CS Memorandum No. 1471

Subject: Configuration Management Board Meeting No. 128

CMB Meeting Minutes #128

SUBJECT: Configuration Management Board Meeting # 128 – Rev. No. 0

\\CS2SA001\NCSm544.1\FinalDesign\Drawings\2-Civil\Water Distribution\Sheet Files CP02\M54422WD303.dwg fbayami Thu Jul 01, 2010 9:46 am WD-303

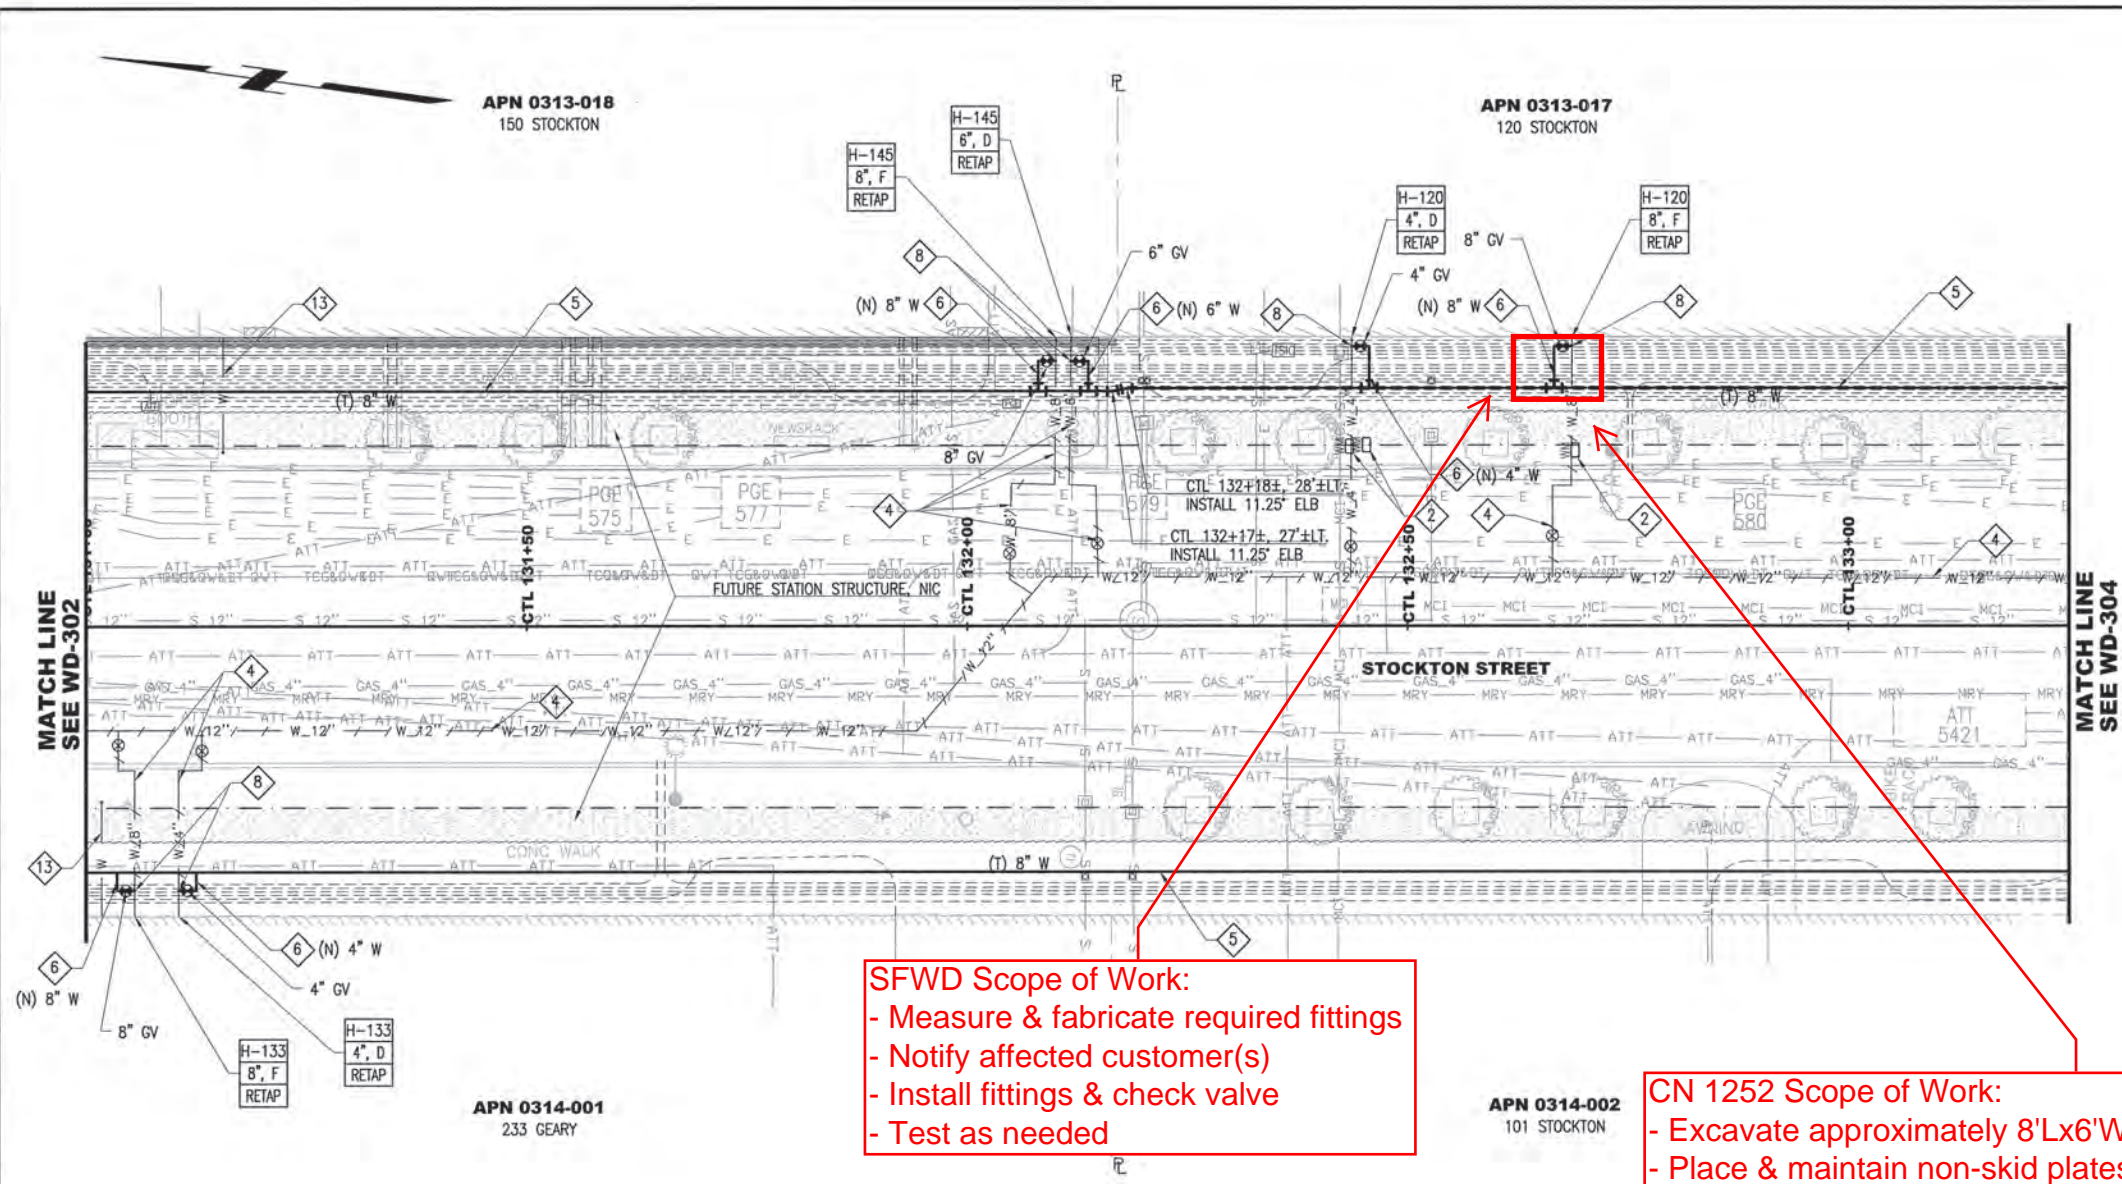
Spec Ref.	CN 1252 Tunnels
Drawing Nos.	WD-303 Rev.0, WD-304 Rev.0
Attachments	FS 1252-051, FS 1252-052
<p>The Contractor's proposal in price and time is required on the this proposed contract change to the subject contract in accordance with the General Provisions Section 6.02 B, within 14 days after receipt of a PCC.</p>

CN 1252 Scope of Work:
 - Excavate approximately 8'Lx6'Wx4'D hole
 - Place & maintain non-skid plates (2 ea.)
 - Remove & re-place plates for SFWD crew (2 occasions)
 - Backfill hole
 - Restore sidewalk

SFWD Scope of Work:
 - Measure & fabricate required fittings
 - Notify affected customer(s)
 - Install fittings & check valve
 - Test as needed

\\CS2SA001\NCSm544.1\FinalDesign\Drawings\2-Civil\Water Distribution\Sheet Files CP02\M54422WD304.dwg ESmatics Thu Jul 01, 2010 9:39 am WD-304

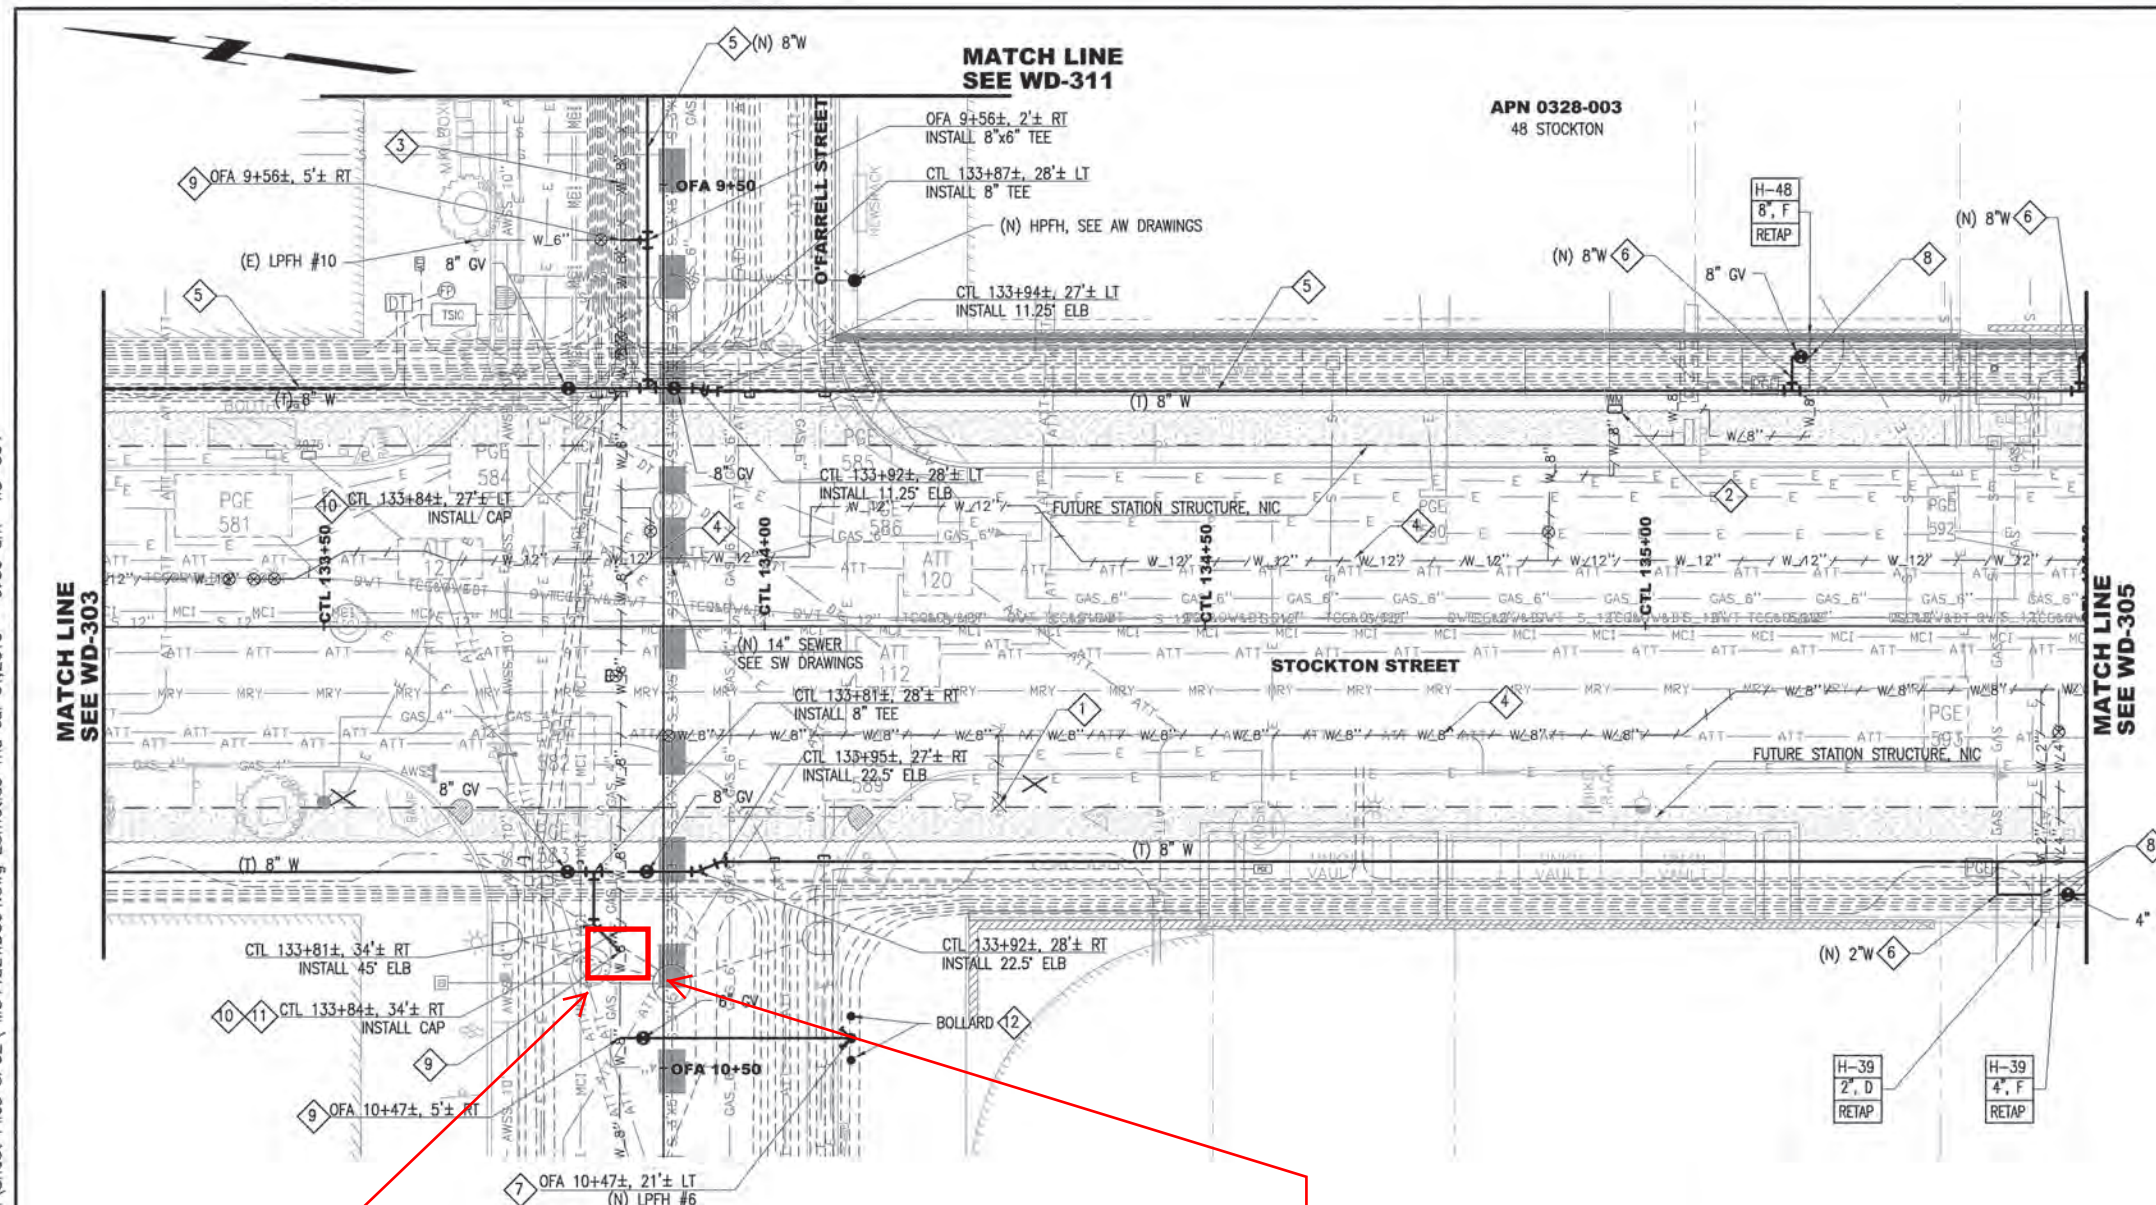
- Excavate approximately 8'Lx5'Wx4'D hole
- Place & maintain non-skid plates (2 ea.)
- Remove & re-place plates for SFWD crew (2 occasions)
- Backfill hole
- Restore roadway

\\s6lnas003\ms644\1\Final\Design\Drawing-821\2-Civil\Utility Demolition\Sheet Files CP03\M54423UD302.dwg FBoyami Wed Jan 26, 2011 - 1:25 pm UD-302

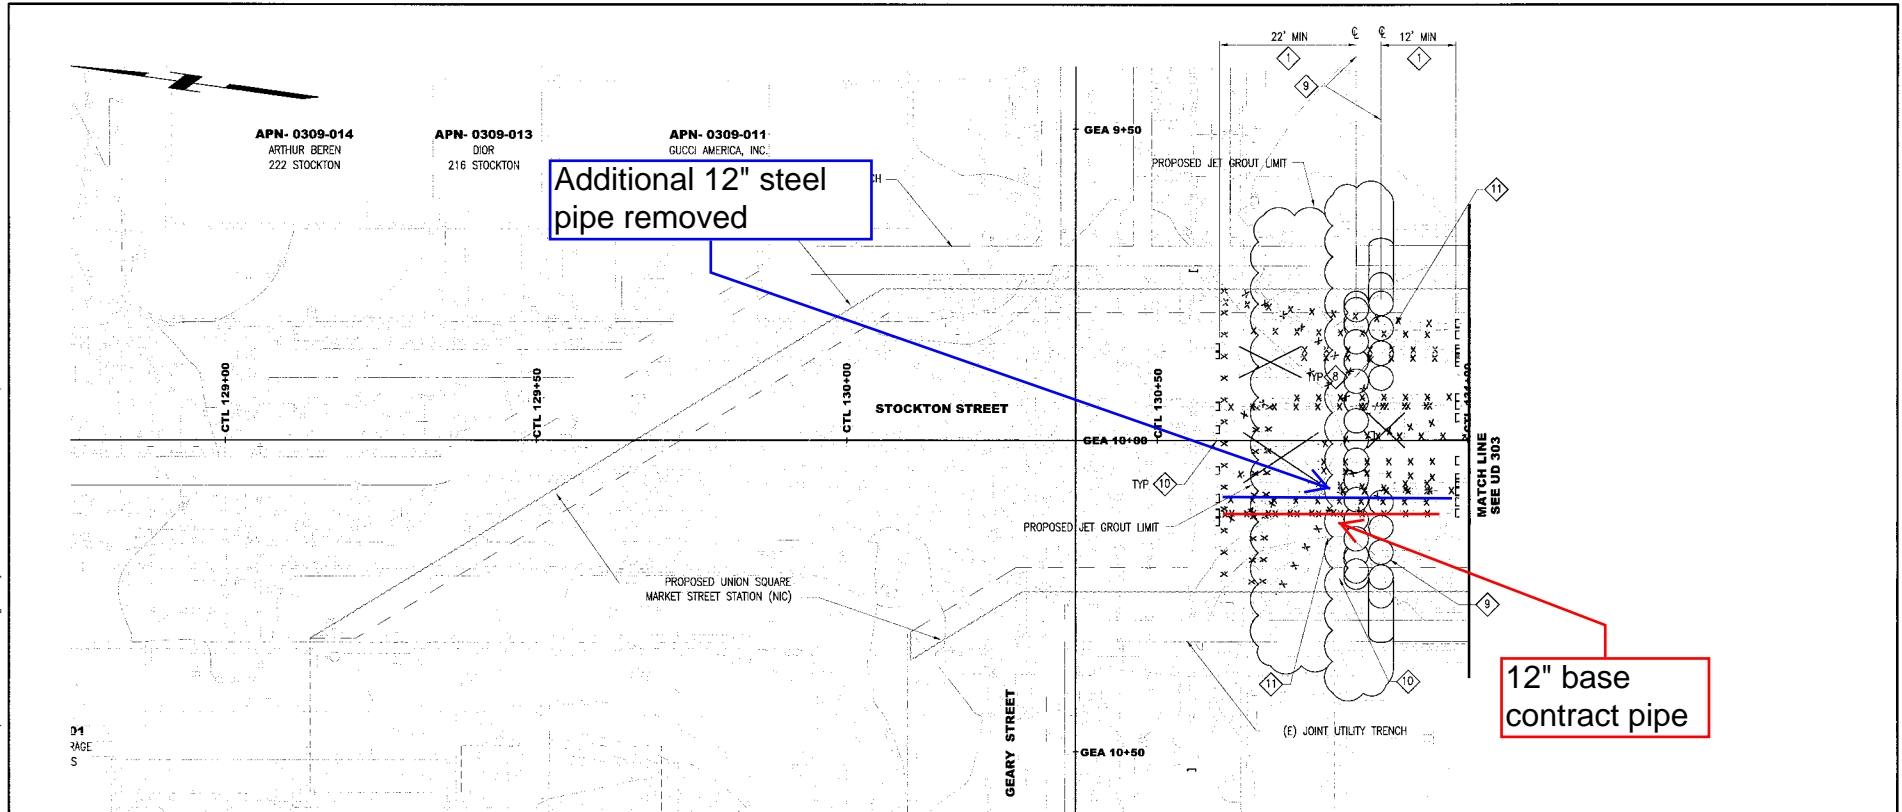
Facts: On August 15th 2012, the Contractor discovered an abandoned 12" steel pipe within the utility demolition limits at the UMS North headwall. On August 16th the Contractor removed the pipe from the utility demolition limits. See attached Field Sketch FS 1252 – 053.

Justification: The Contract Drawings, specifically UD-302 rev.0, did not show the abandoned 12" pipe which constitutes a differing and unforeseen site condition. Removal of the pipe was necessary for headwall construction at this location. SFMTA inspectors have verified that additional labor and equipment resources were required to facilitate removal of the abandoned 12" pipe.

Recommendation: Accept justification of Merit for COR 037, for the removal of an abandoned 12" steel pipe at the North UMS headwall. There is no time extension requested or recommended for this work.
